Optical measurements: bandwidth of the roll-off (or cut-off) of the Bessel-Thomson filter.

Re. of the end-of-compliance of the Bessel-Thomson filter for the TECQ/TDECQ measurements as in comments R2-205, R2-188

Pavel Zivny, Lumilens

2026/Sept., for the “P802.3dj Lisbon meeting”

Figure 180–7—Reference receiver block diagram

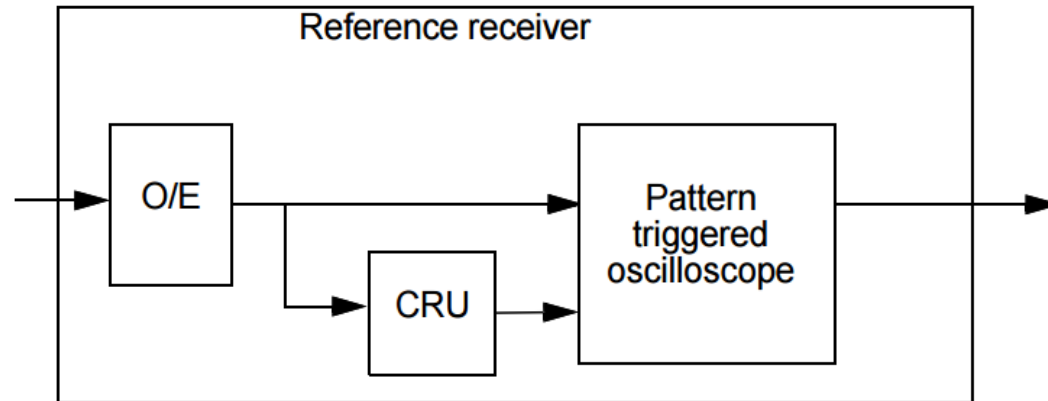
- A reference receiver is defined for transmitter measurements. The reference receiver is composed of an O/E converter, a clock recovery unit (CRU), and a pattern-triggered oscilloscope as shown in Figure 180–7. The combined frequency response of the O/E converter and oscilloscope has a 3 dB bandwidth of approximately 53.125 GHz with a fourth-order Bessel-Thomson response for frequencies up to at least **1.3 x 106.25 GHz** and a response no higher than –20 dB for frequencies greater than 1.3 x 106.25 GHz [bold mine, prz]
- So as is, the 4th order B-T has to be followed to **at least 138.125 GHz**, this is unduly difficult with amplified SM in 2026* (and probably impossible at MM in 2026)

1st order dependency: $\text{TECQ} = f(\text{ORR_BW})$

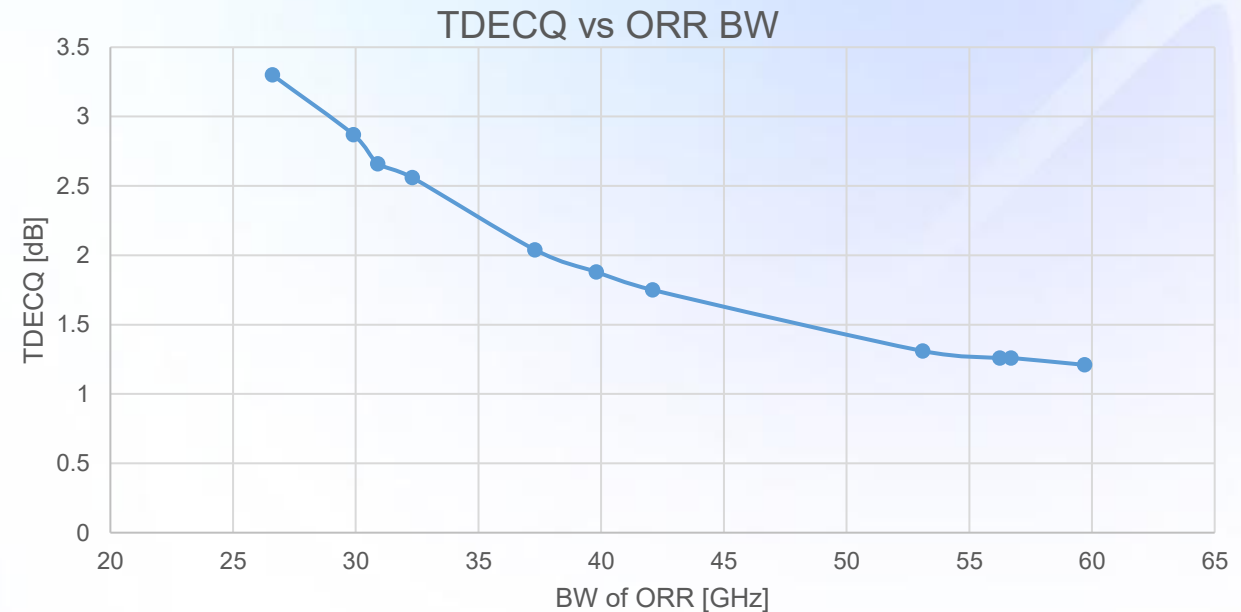
- lowering the Bessel-Thomson $\text{BW}_{-3\text{dB}}$ shows the expected dependency of TECQ result to the BW of the B-T
- The cut-off is still at a very high frequency similar to 138 GHz of the D3.2

- Reasonable; leave this ORR BW as is.

2nd order dependency: TDECQ = f(ORR_BW Cut-off)

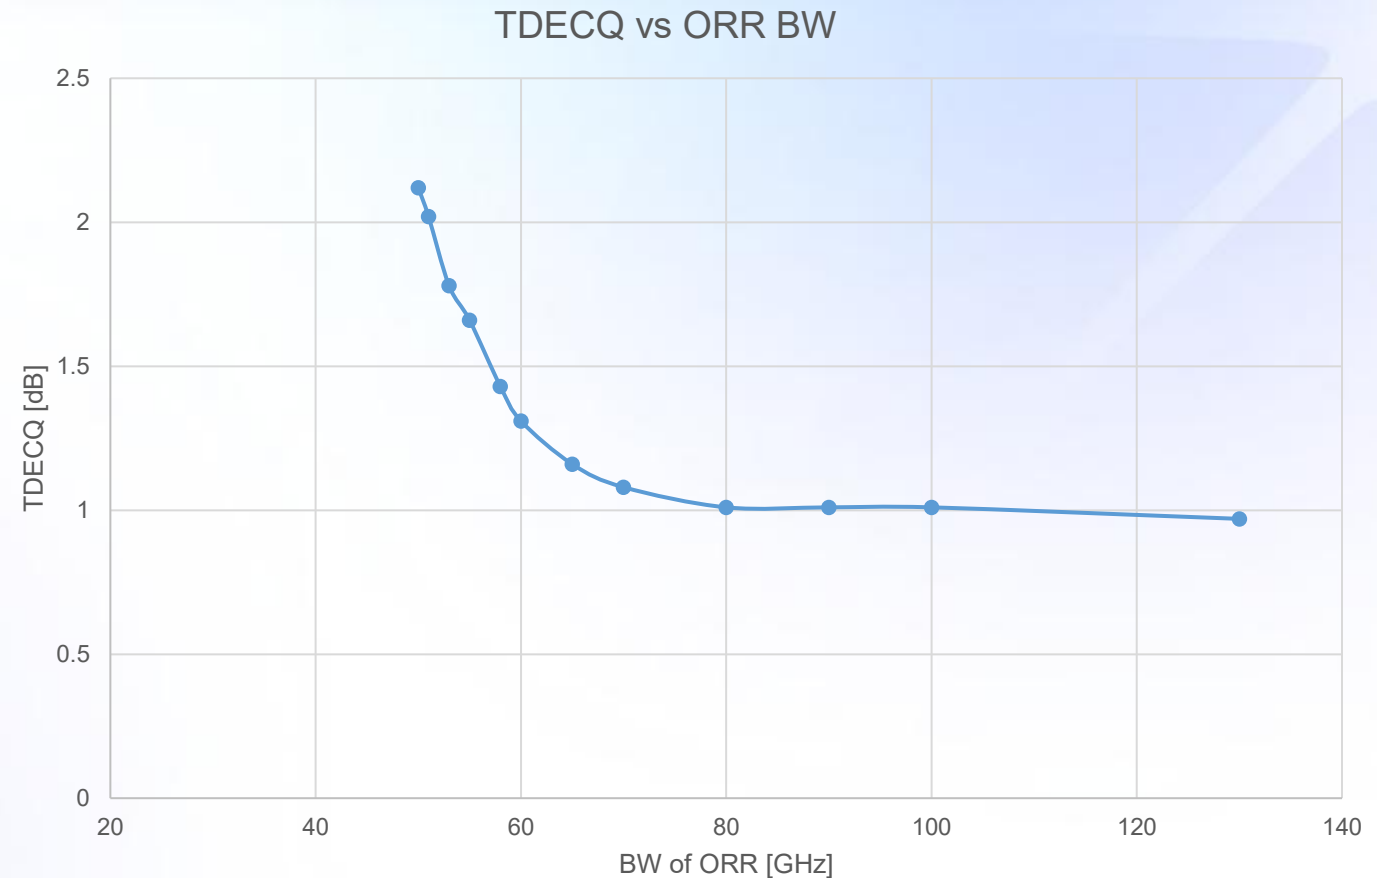
- Cutting the Bessel-Thomson BW tail
- (cut-off implemented as a 10th Order Butterworth filter; others show same result)
- Observe a (left) hockey-stick dependency of TDECQ on the BW cut-off of the frequency response
- The TDECQ value is stable above ca. 80 GHz

Frequency-domain view (measured signal)

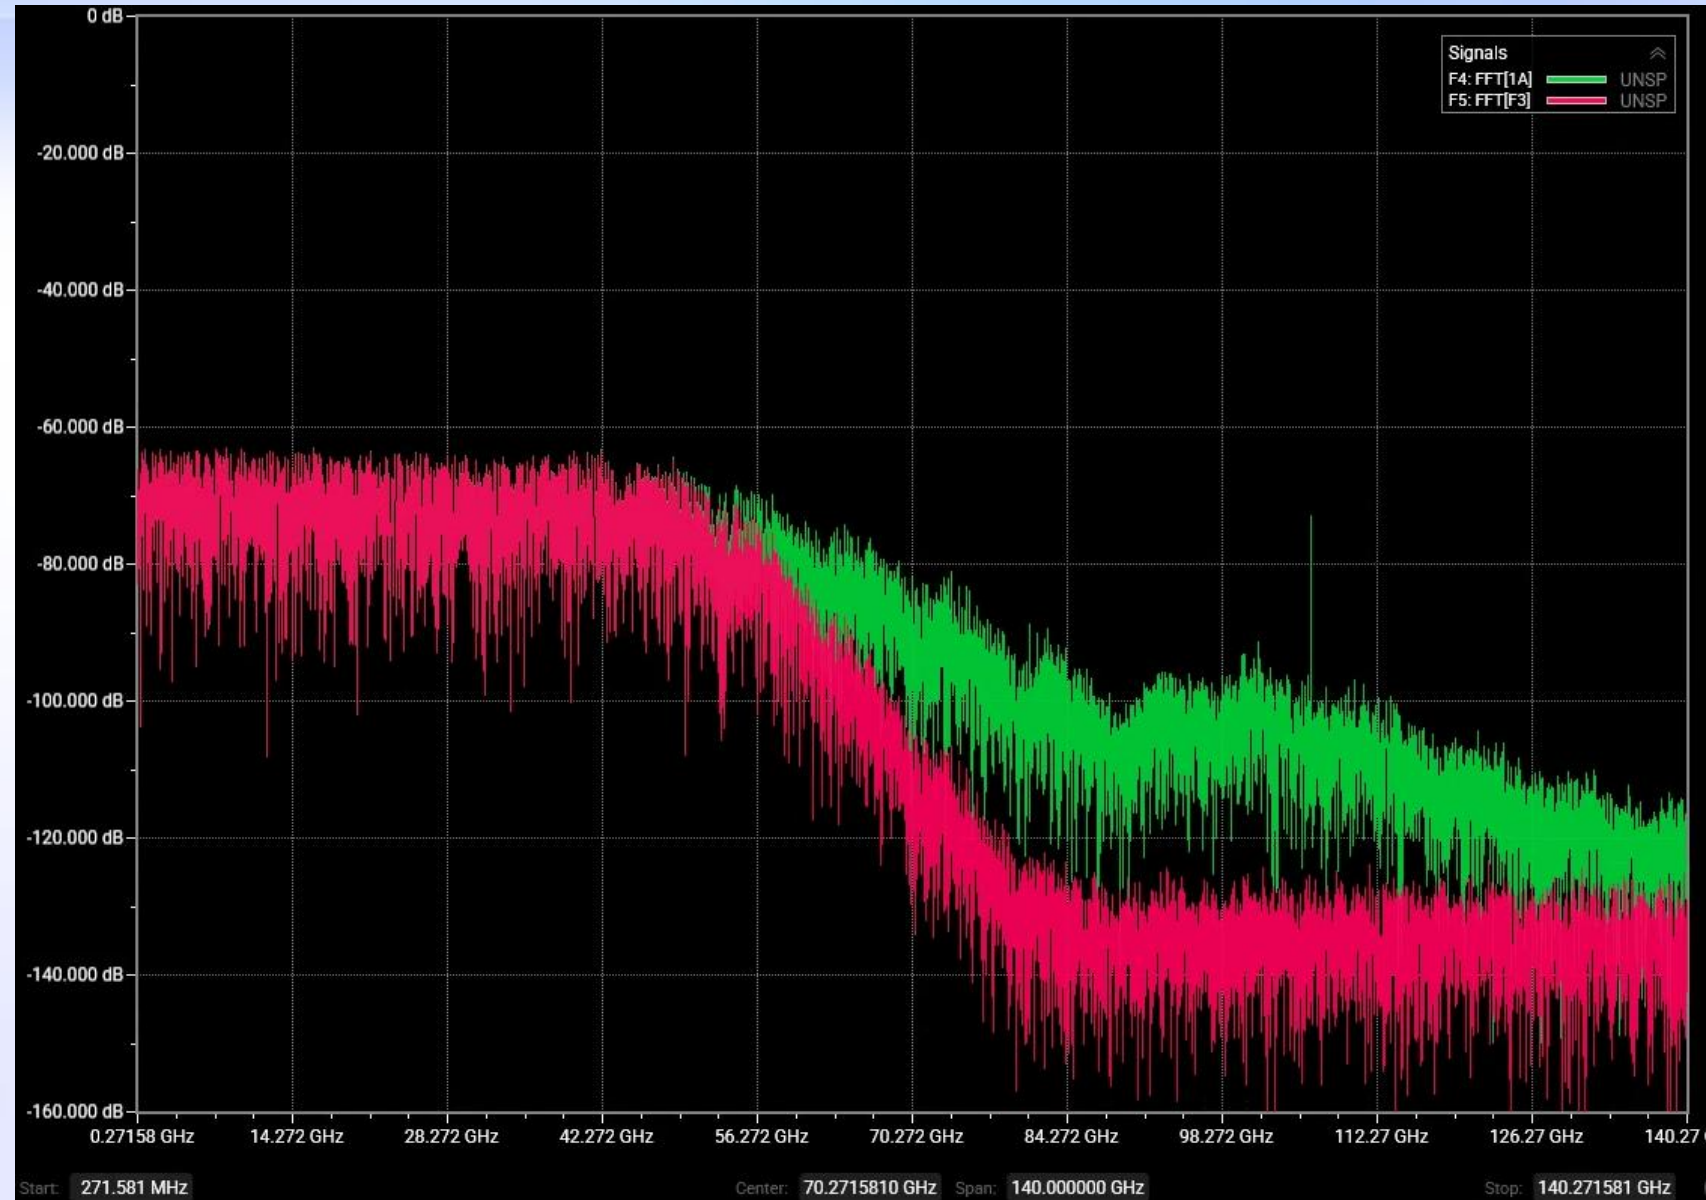
- Green trace: spectrum with just Bessel-Thomson 4th order
- Red trace: same signal, but here the B-T spectrum is cut-off with a Butterworth (in this example to 55 GHz)
- Note that the signal has little energy past 90 GHz

Conclusion: we don't need to measure with bandwidth controlled to 138 GHz ... and we shouldn't
